May 30, 2013

Re: ENERGY STAR Program Requirements, Product Specification for Residential Refrigerators and Freezers Final Draft, Version 5.0 and Final Draft Test Method to Validate Demand Response

**EFFECTIVE DATE CHANGE FOR REFRIGERATOR-  
FREEZER ENERGY STAR PROGRAM**

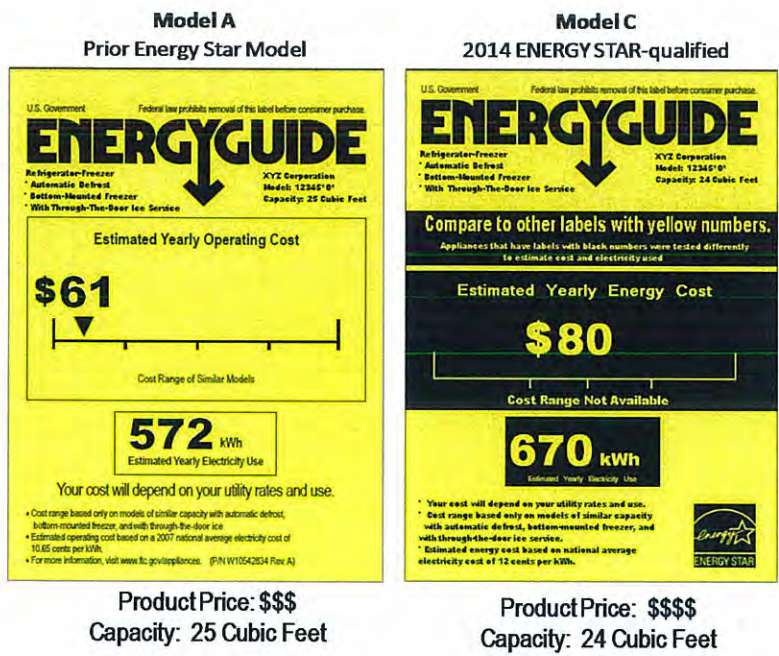
The following images for a typical bottom-freezer model, with Model A representing the now disqualified ENERGY STAR model and Model C representing the new 20% more efficient model illustrate the problem:

Should consumers compare these two models on the retail floor, the lower cost and kWh consumption information on the EnergyGuide label will likely drive their purchasing decisions to Model A, which actually uses 109kwh/yr more energy, when tested under the provisions of the 2014

Not only does the label indicate—incorrectly—that Model A is more efficient and less costly to operate, consumers also “learn” that it is *one cubic foot larger!* This is a further confounding consequence of the DOE test procedure change, which, in redefining capacity for dispensing models, deducts volume associated with the dispensing mechanism that was previously included in the calculation.

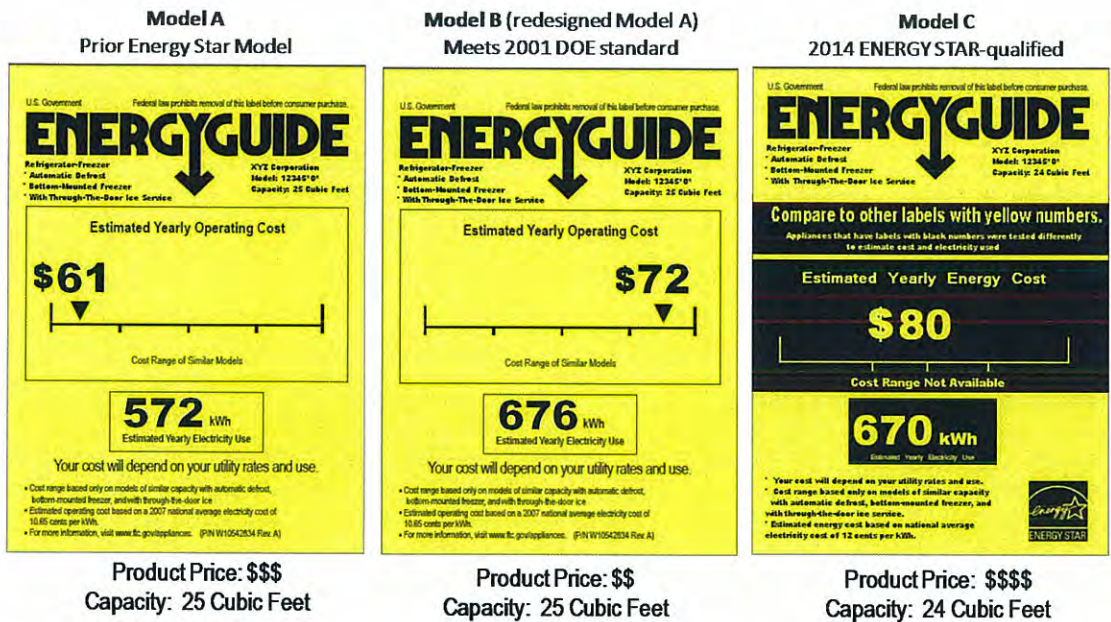
The potential impact of product redesign is illustrated in the below mocked-up Energy Guides for Models A, B and C, which, respectively, represent a pre-March 2014 ENERGY STAR model, that same model redesigned to take its energy efficiency level down to the 2001 DOE standard level, and a comparably featured new model that meets the 2014 ENERGY STAR level for bottom-freezer refrigerators.

Although the labels read as if Model C is the most costly to operate, it is actually *13% more efficient than Model A and 26% more efficient than Model B and, despite the stated \$80 annual operating cost, less expensive to operate than either of the other models.*
